**Memorandum**

**Subject:** Request for Removal Action Housatonic River 1 ½-Mile Reach at the GE-Pittsfield/Housatonic River Site, Pittsfield, Massachusetts—**Action Memorandum and Exemption from the Statutory \$2,000,000 and 12-Month Limits on Removal Actions**

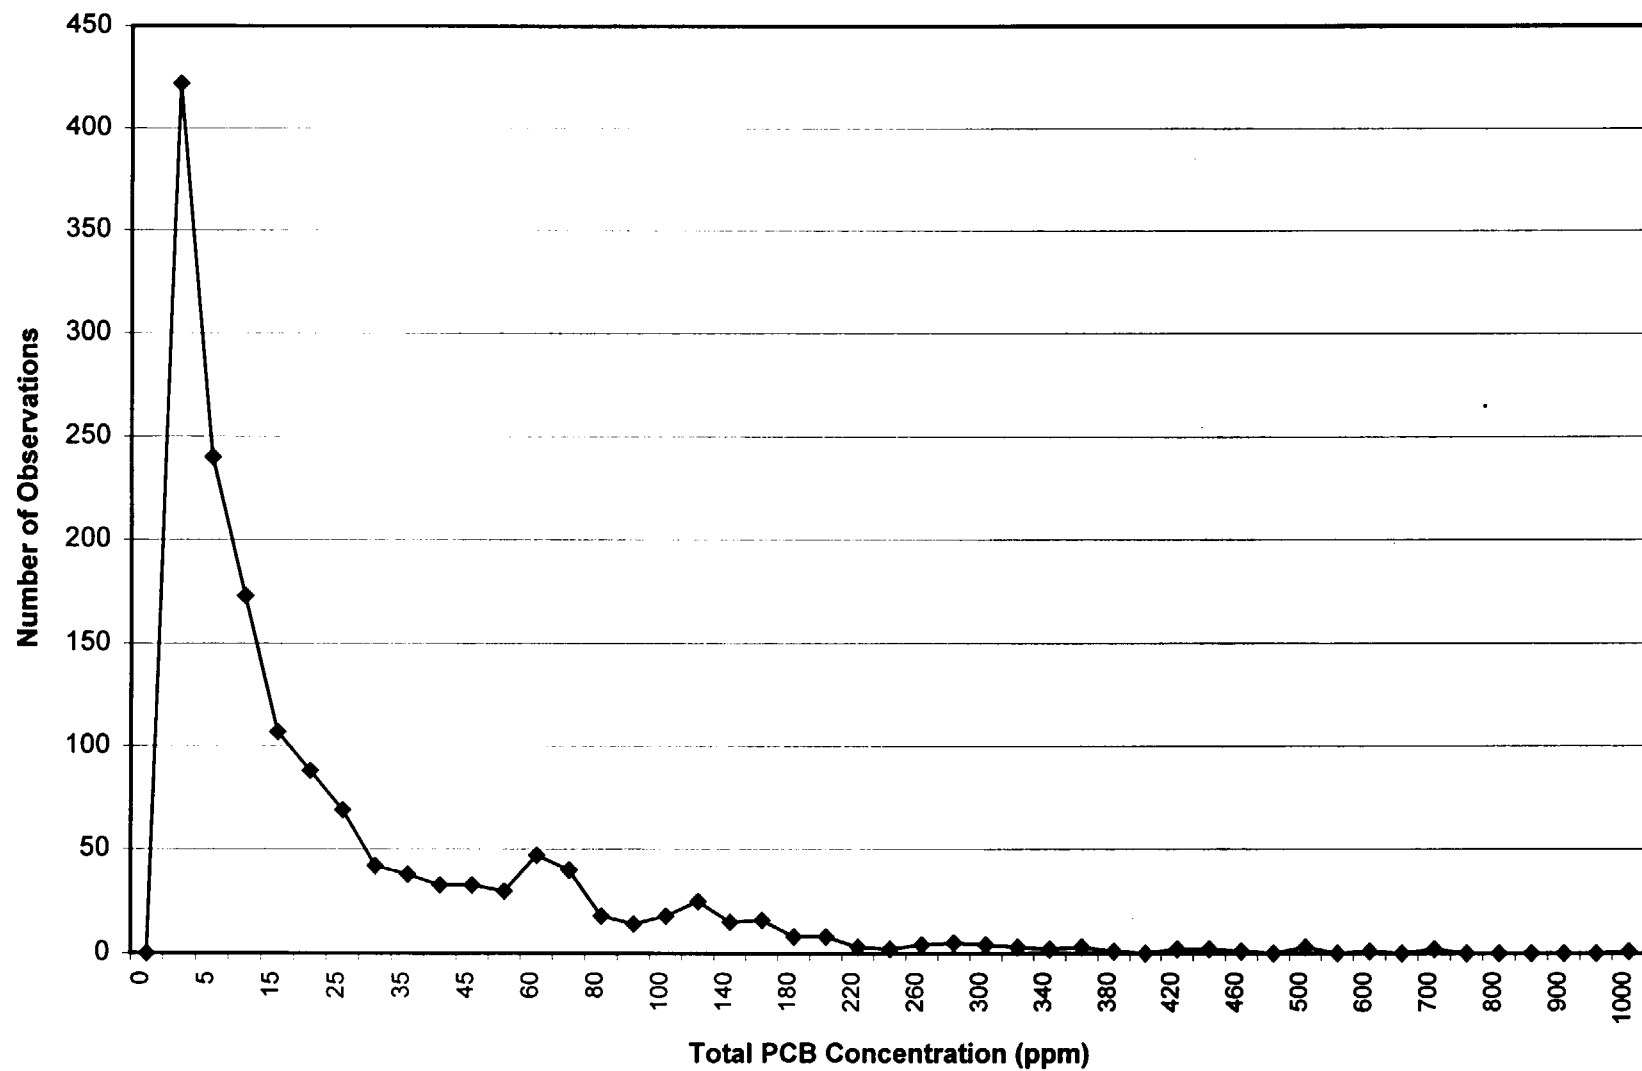
**78) Comment:** *Question 4, Bullet 3. It should be noted that the actual location of the proposed walls is not well-defined in the EE/CA. Drawings 2.1 6A through D show the walls may be located in various sections at the toe, middle, or crest of the slope, but Drawing L-3 of Appendix L indicates they will be constructed at the toe. It is unclear which wall locations were assumed during calculation of volumes. Obviously, the selection of these locations will have a significant impact on the removal volume.*

**EPA Response:** In the EE/CA Report the retaining walls were typically located at or near the toe of the riverbank slope. The actual location, height, and extent (length) of the proposed retaining walls will be determined during final design. The retaining walls will be constructed of gabions, steel sheetpile, metal-bin cribs, concrete, cemented masonry, or modular blocks. The actual wall type will be selected during design to minimize excavation as limited by required wall height and site-specific conditions.

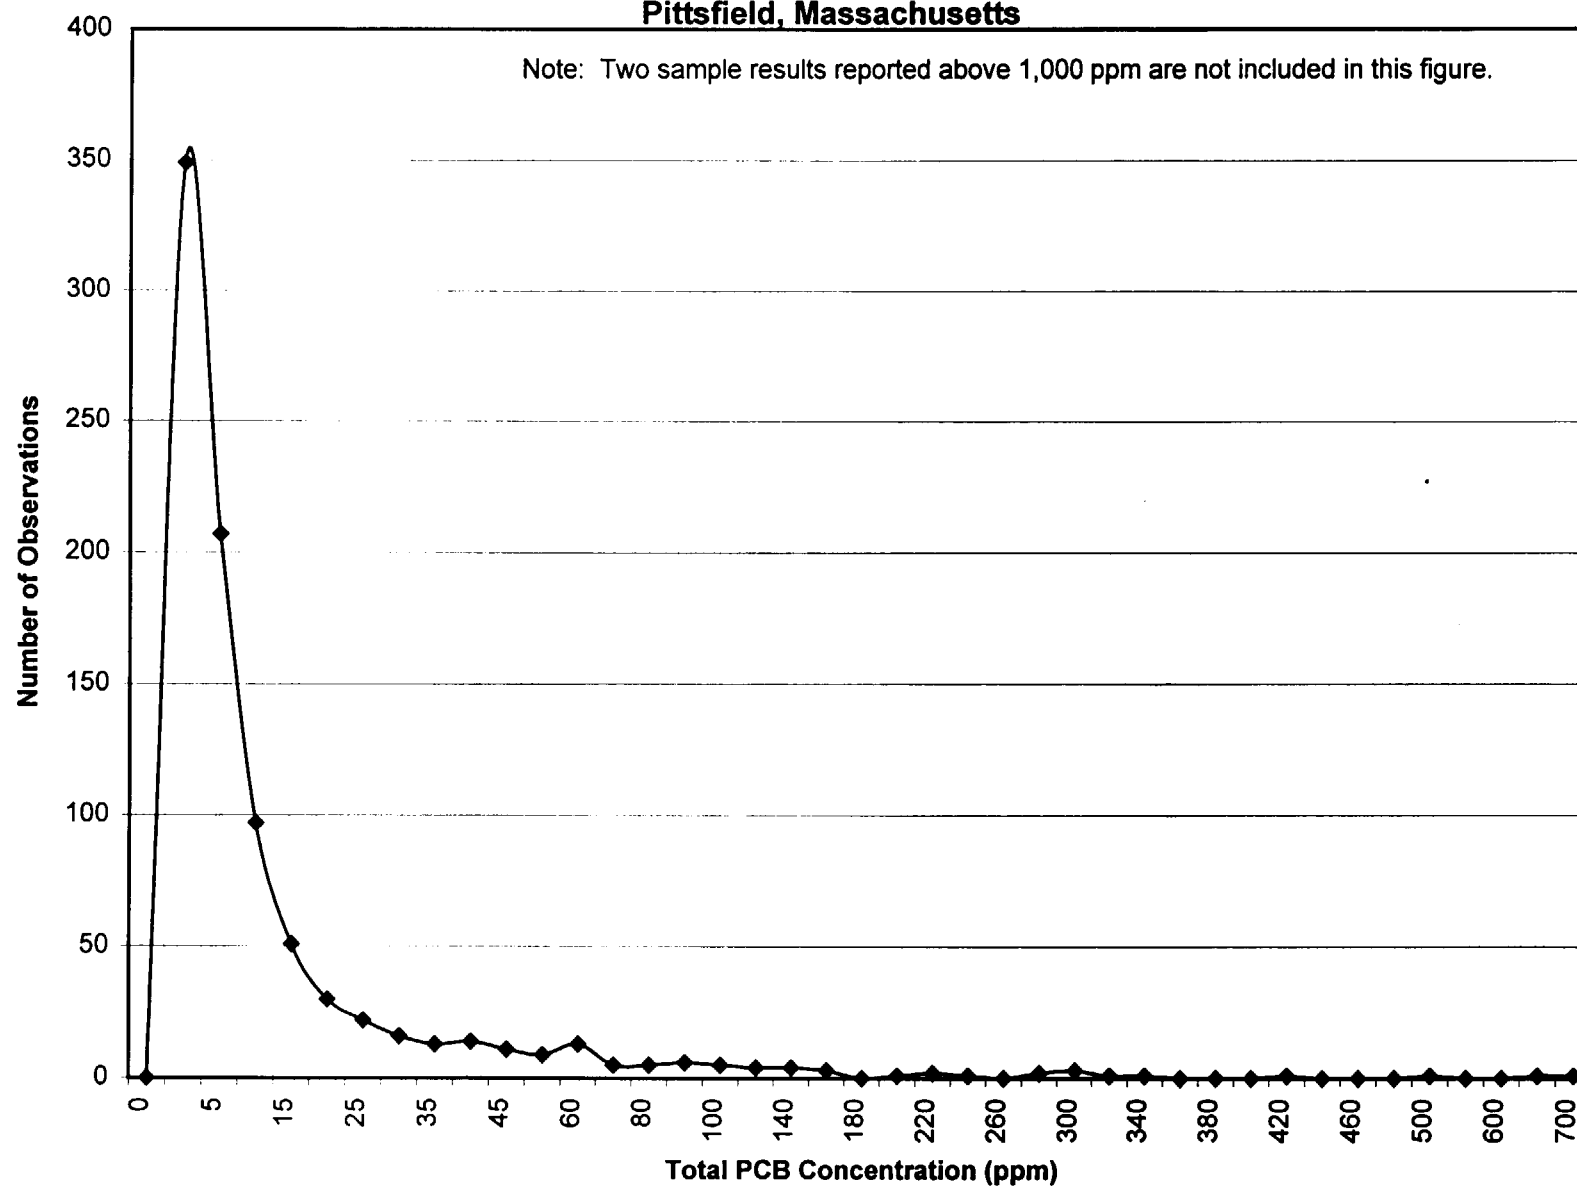
**79) Comment:** *GE concludes its comments to Attachment A by asking how the additional volumes associated with these issues are accounted for?*

**EPA Response:** EPA disagrees with GE's assertion that the volume estimates in the EE/CA Report are incorrect. See EPA Response to Comments 59 and 71-79.
